[1] TEDD RED LINE #1 - RELOCATE RAMPS. REPLACE DAMAGED SIDEWALK. INSTALL ADDITIONAL PAVEMENT MARKINGS - 10/9/08

US 13 BUSINESS (SALISBURY BOULEVARD) AND NORTH BOULEVARD

TRAFFIC SIGNAL PLAN

TS NO. 1936-C

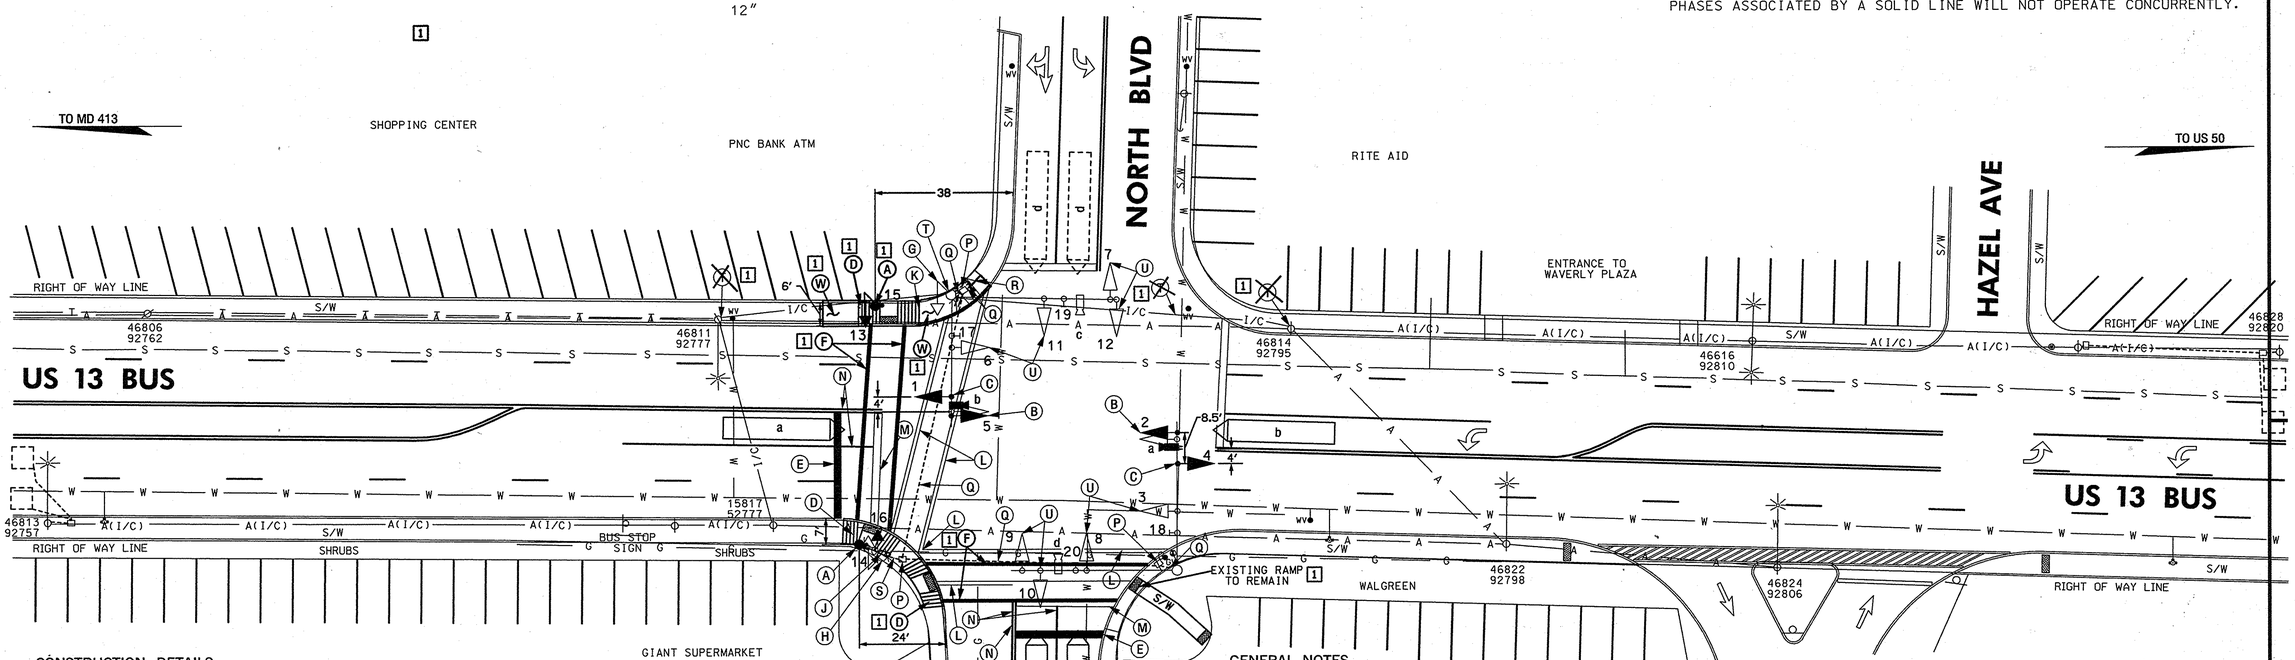
S. CAP AND ABANDON EXISTING CONDUIT.
~~T. DISCONNECT EXISTING INTERCONNECT RUN FROM THE NORTH. PULL BACK TO WOOD POLE #46014/ 92795 THEN RERUN TO TOP OF THE EXISTING MAST ARM AND BACK INTO THE EXISTING WEATHER HEAD.~~ [1]

U. INSTALL LED SIGNAL HEAD MODULE IN EXISTING SIGNAL HEAD.
V. REMOVE EXISTING PAVEMENT MARKING LETTERS.
W. INSTALL 5 INCH CONCRETE SIDEWALK WITH STANDARD TYPE A CURB AND GUTTER. [1]
